UNITED STATES PATENT AND TRADEMARK OFFICE

APPLICATION NO.	FILING DATE	FIRST NAMED INVENTOR	ATTORNEY DOCKET NO.	CONFIRMATION NO.
09/920,640	08/03/2001	Steve Mead	12440-02/ejg	6057

# Office Action Summary

## **DETAILED ACTION**

3,548,559

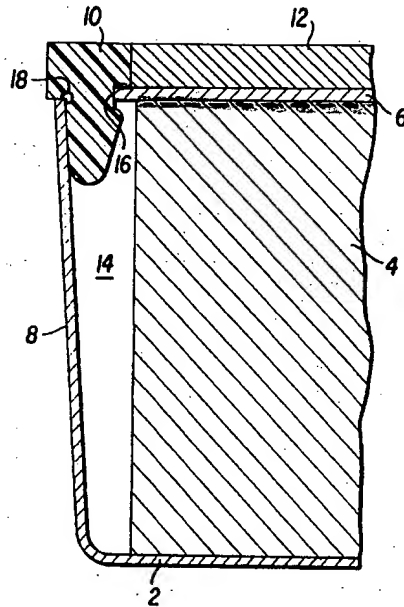
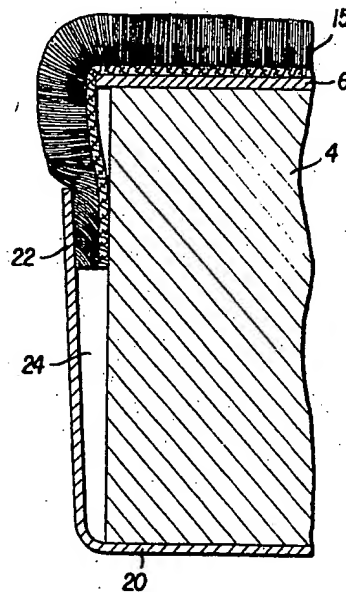
4. Claims 1-4, 7-8 and 11 are rejected under 35 U.S.C. 102(b) as being anticipated by US Patent #3,548,559 to LEVINE. Regarding claims 1 and 7, LEVINE discloses the use of a floor panel including a base (4) having a planar load bearing surface (colored red), an inner planar covering (6) adhesively secured to the base structure (4), column 1, lines 64-65, and outer planar

floor covering (12) adhesively bonded to the inner floor covering (6), column 1, lines 69-70; wherein, the inner floor covering (6) extends beyond the outer floor covering (12) to form a border (colored blue), see the marked attachment. In reference to claims 2 and 8, the outer floor covering (12) is vinyl or an asbestos tile, thereby being a decorative surface. Regarding claims 3 and 8, the inner floor covering (6), although metal, is also a decorative surface and because it is metal. Metal is usually has a grey tone. Although shiny, metal is a fairly “dark” surface, especially in consideration to other surfaces such as clear resin films, white, tan or beige colored finishes. In reference to claim 4, the border (colored blue) includes an edge that lies in the same plane as the inner panel (6). Further regarding claim 7, the base structure (4), the inner covering (6), and the outer covering (12) are all rectangular. The inner floor covering (6) is co-extensive with the base structure (4), the outer floor covering (12) is a separate element, and the border (colored blue) present a peripheral edge for maintaining edge trim (10). Regarding claim 11, LEVINE discloses that the panels of his system are assembled to form an elevated floor assembly from wall-to-wall. Inherently, flooring systems of this type are arranged in edge-to-edge abutting contact.
